Title - Sujet Reconst. Manège militaire Québec	
Solicitation No. - N° de l'invitation EE520-151410/B	Amendment No. - N° modif. 012
Client Reference No. - N° de référence du client EE520-151410	Date 2015-02-25
GETS Reference No. - N° de référence de SEAG PW-\$QCM-009-16291	
File No. - N° de dossier QCM-4-37219 (009)	CCC No./N° CCC - FMS No./N° VME
Solicitation Closes - L'invitation prend fin at - à 02:00 PM on - le 2015-03-12	
F.O.B. - F.A.B. Plant-Usine: <input type="checkbox"/> Destination: <input checked="" type="checkbox"/> Other-Autre: <input type="checkbox"/>	
Address Enquiries to: - Adresser toutes questions à: Thellend, François	Buyer Id - Id de l'acheteur qcm009
Telephone No. - N° de téléphone (418) 649-2889 ()	FAX No. - N° de FAX (418) 648-2209
Destination - of Goods, Services, and Construction: Destination - des biens, services et construction:

AMENDMENT 012

- 1) Clarifications;
 - 2) Amendment to the Invitation to Tender;
 - 3) Technical addendum 005; and
 - 4) Questions and answers #217 to 382.
-

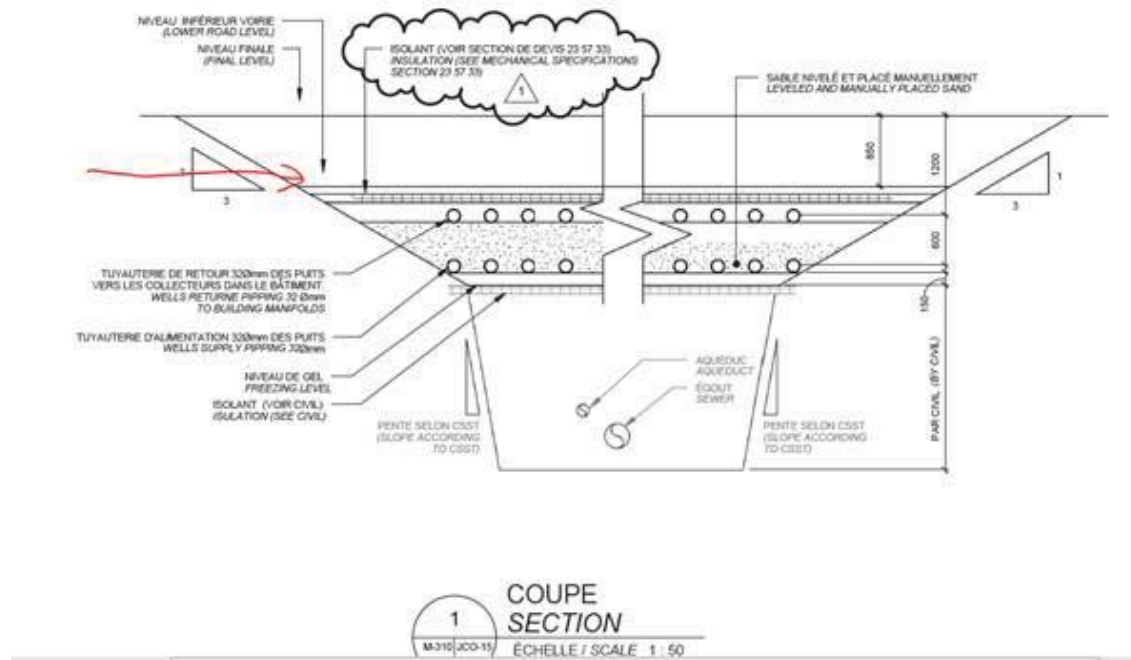
Question regarding geothermic:

- Will the current layer of asphalt that covers the geothermic area be removed by the general contractor?
- Will the last 850mm between the insulation sheet and the ground level need to be filled by another? (See figure below)

- There seems to be missing information regarding the excavation (type of sand, necessary compaction test). Could this information be provided?
